FINAL MITIGATION PLAN

**Stony Fork Restoration Site
Johnston County, North Carolina
DMS Project Number 97085
DMS Contract 6830
USACE AID SAW-2016-00875
DWR Project Number 2016-0372**

NC Department of Environmental Quality
Division of Mitigation Services
1652 Mail Service Center
Raleigh, NC 27699
September 5, 2018

FIGURE 10. PROPOSED MONITORING PLAN, STONY FORK RESTORATION SITE, JOHNSTON COUNTY, NC

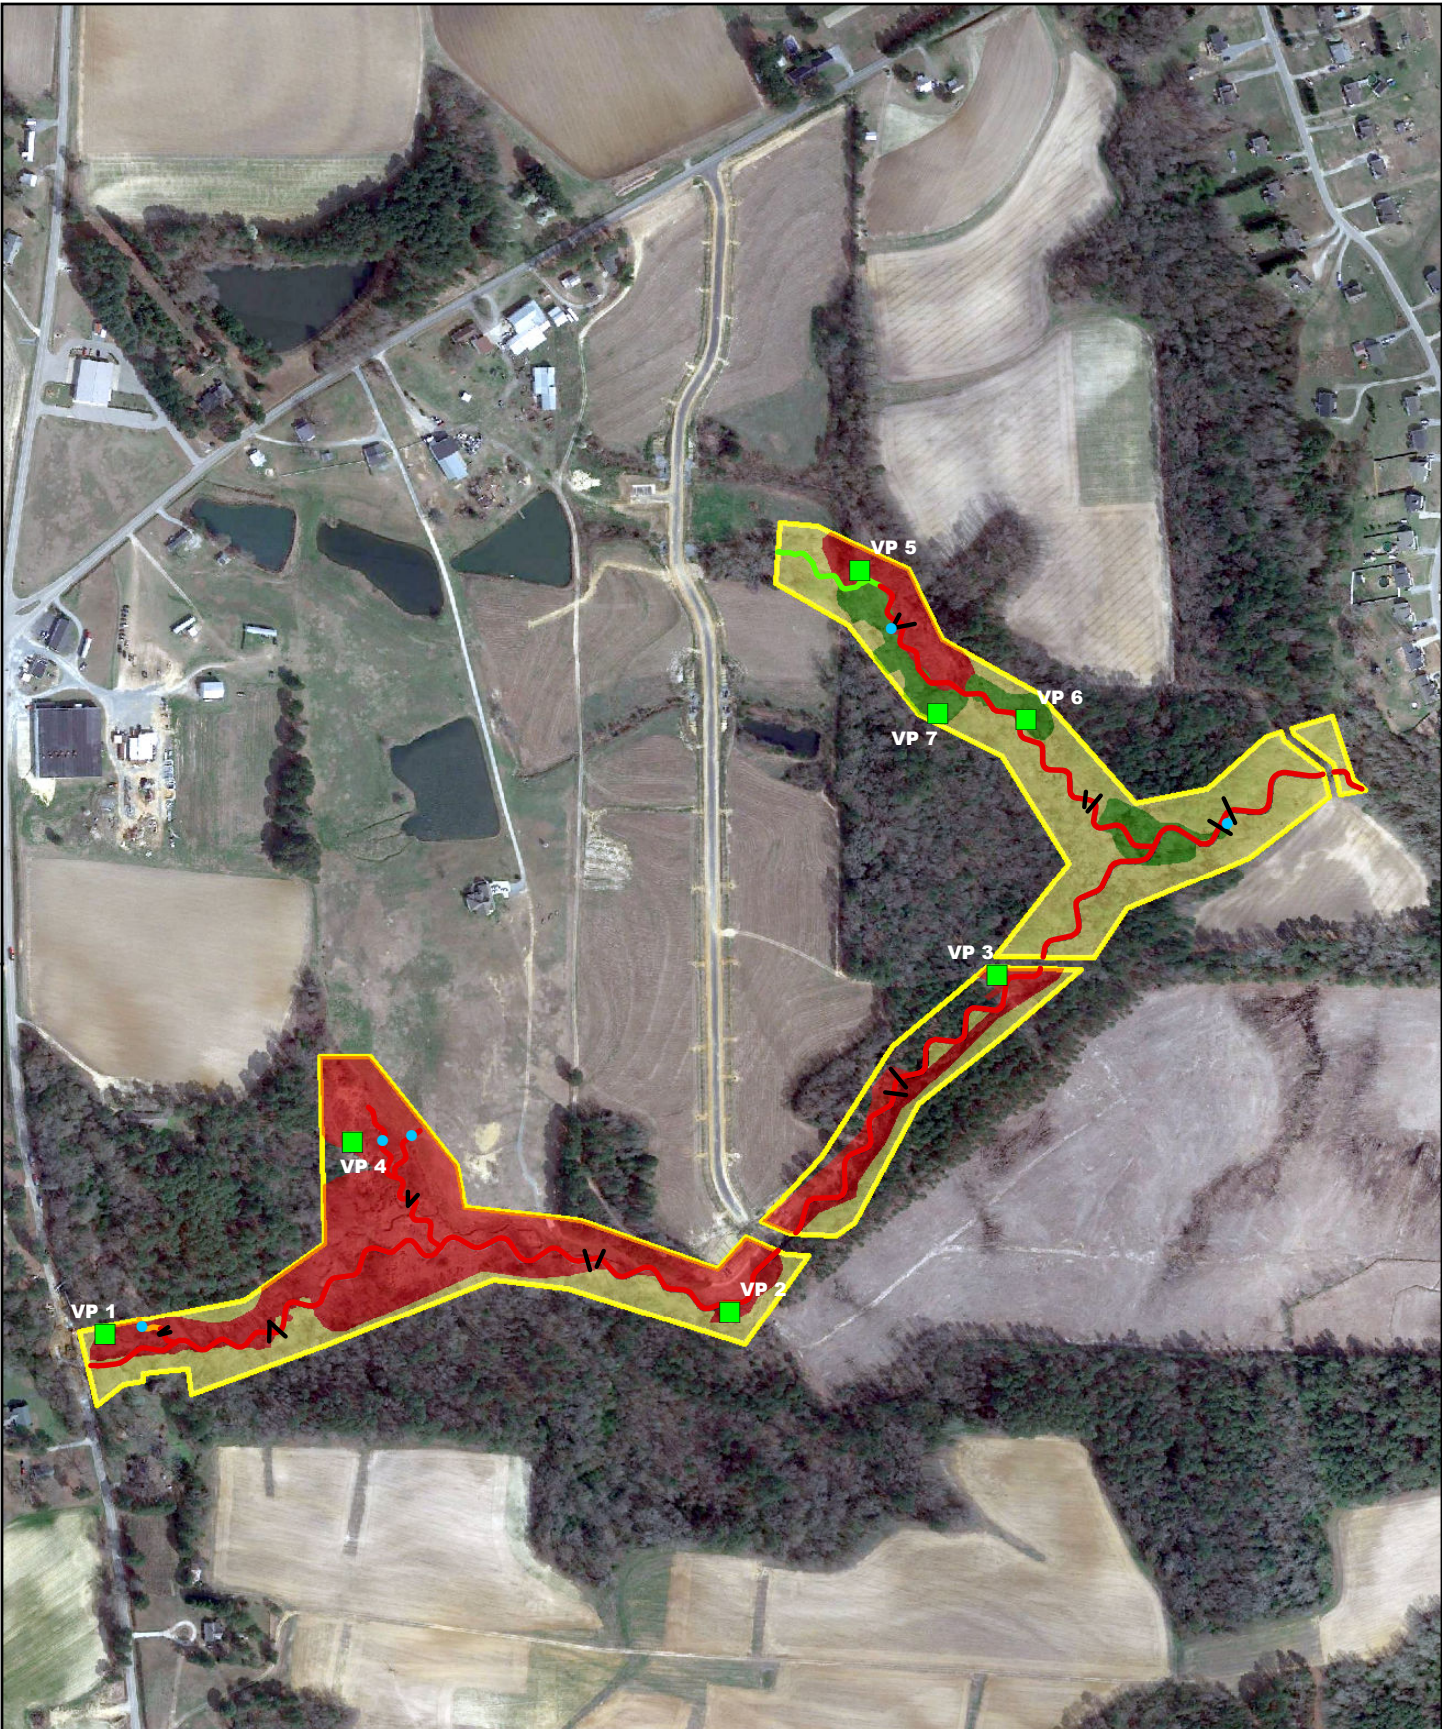
- vi. Figure 10 shows the approximate location of monitoring plots. --DWR recommends ensuring that each reach has a plot located on both sides of the stream where restoration or enhancement is being generated for buffer mitigation.
-Please do not place plots within or partially within a buffer preservation area.

None of the current plots are mapped within preservation areas, although they may appear close to the boundaries at the scale of Figure 10.

We have included another permanent plot along T2’s right bank as requested – please see the revised Figure 10 in the attachments and plot table below.

SITE PLAN
 REACH:
 SF1, SF2 &
 T1, T1A, T3

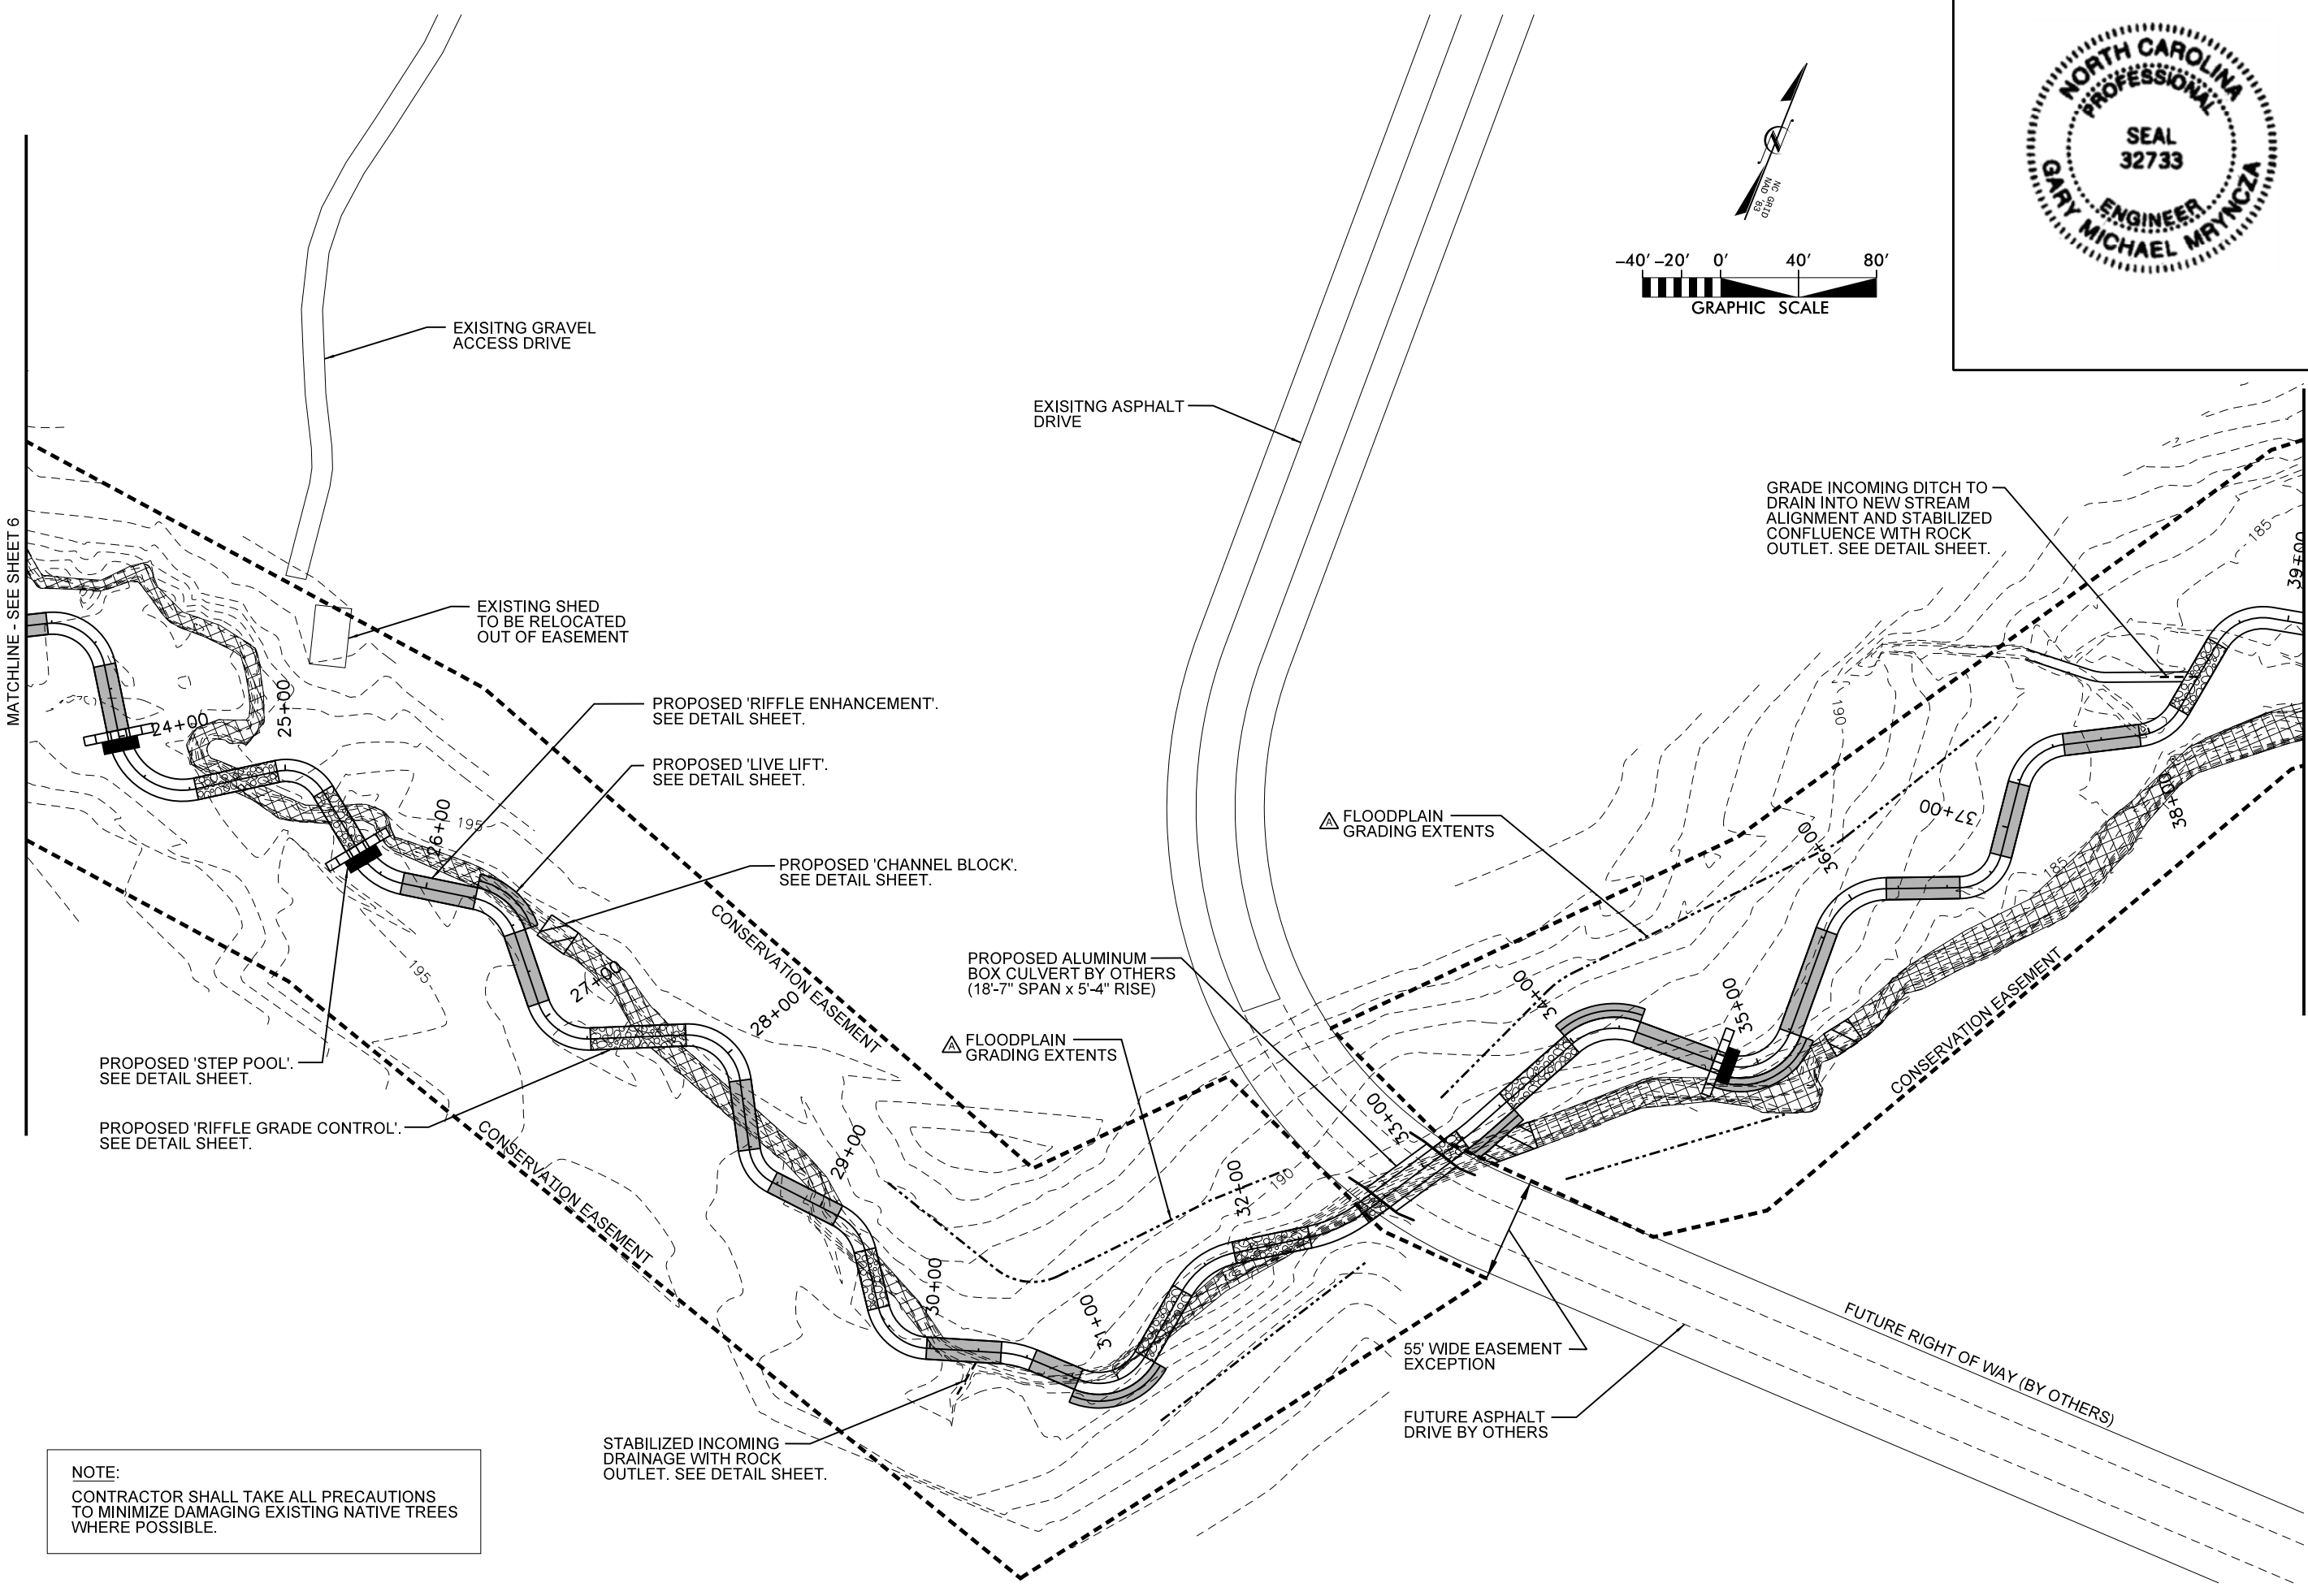
- a. Sheet 6: Tributary 1B & 1A are new tribs proposed off T1. Buffer Credit will need to be deducted from the footprint where these streams will be located. Figures provided in this plan do not currently show that deduction. Buffer credit is only viable adjacent T1.

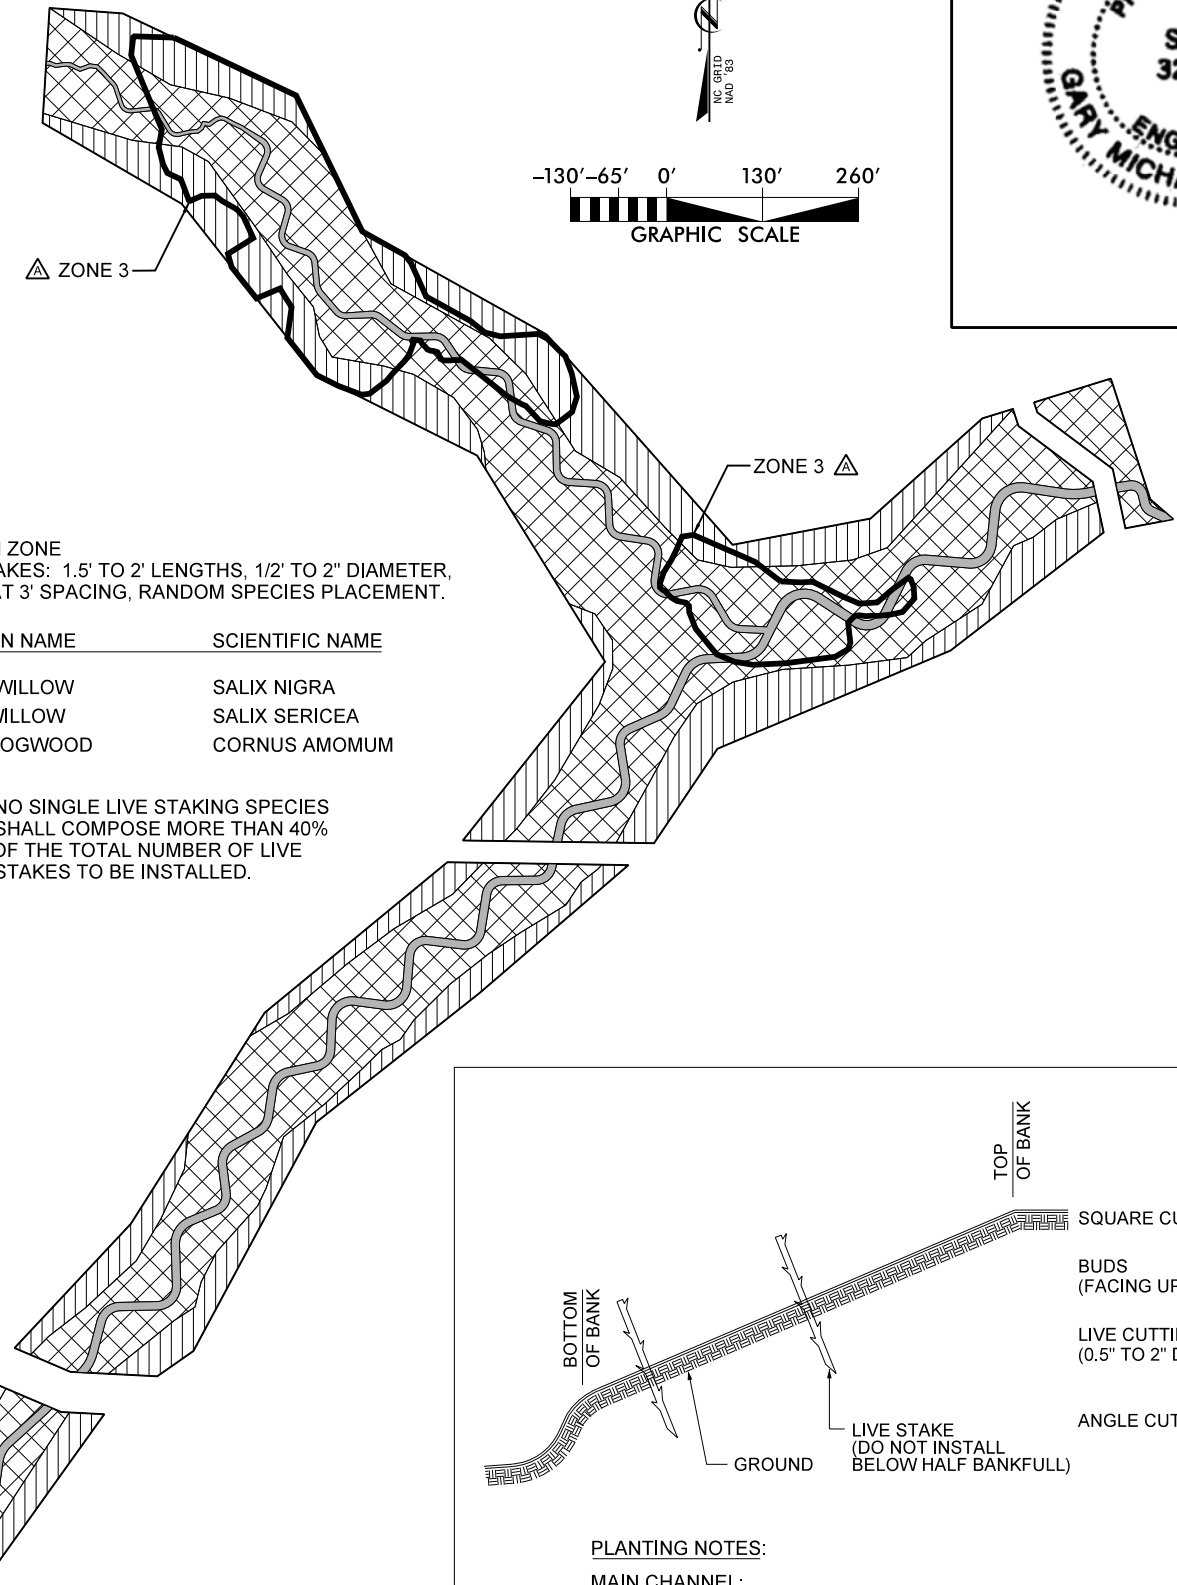
- b. Sheet 14: bare roots are the only size of stems shown to be planted other than live stakes. Is KCI not intending on planting larger stock within the buffer Enhancement areas along T2.2? (see viability letter note)
